ENGINEERING CHANGE NOTICE
DART AEROSPACE LTD

Date:	19-Jul-19	Job No.:		ADR Yes/No:	N	ADR Date:		ECN #:	19- 822
Product No.:	D412-724			Created By:	MG	Approved By:			
Product Name:	Replacement Head Rests			Checked By:	NO

Product #: D412-724/D412-769
 Product Name: HEAD REST /AFT FACING SEAT

DESIGN RF	DRAWN BY RF	DART AEROSPACE LTD HAWKESBURY, ONTARIO, CANADA		
CHECKED 	APPROVED 	DRAWING NO. D3304	REV. B	SHEET 1 OF 4
DATE 05.07.15		TITLE TUBE ASSEMBLY	SCALE 1:6	
A	04.08.18	NEW ISSUE		
B	05.07.15	UPDATE DIMENSIONS; ADD D3304-7/-8

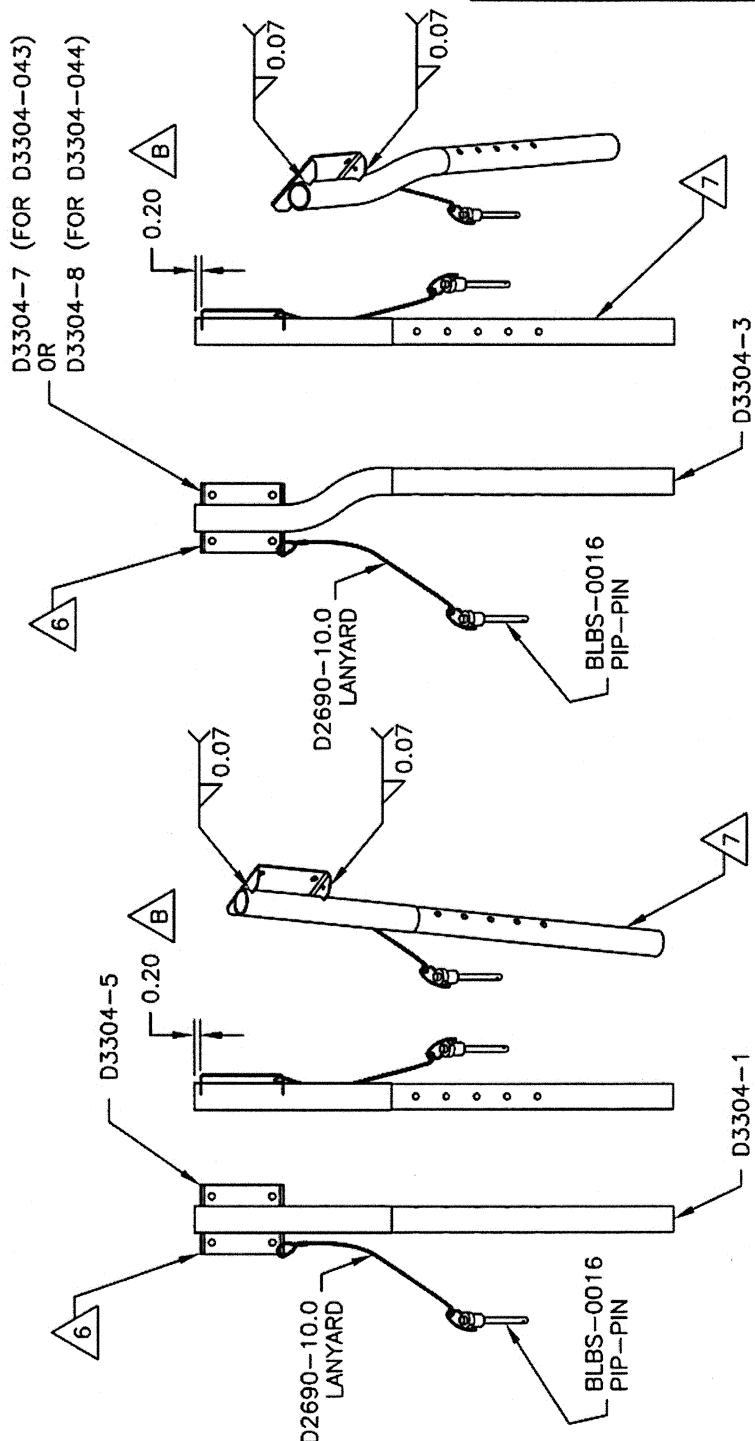
D3304-041/043/044 drawings needs to be revise to replacing BLBS-0016 pip pin with NAS1353DS7S13D pip pin's to comply with AD CF-91-29R1 for the 205A-1 and 212
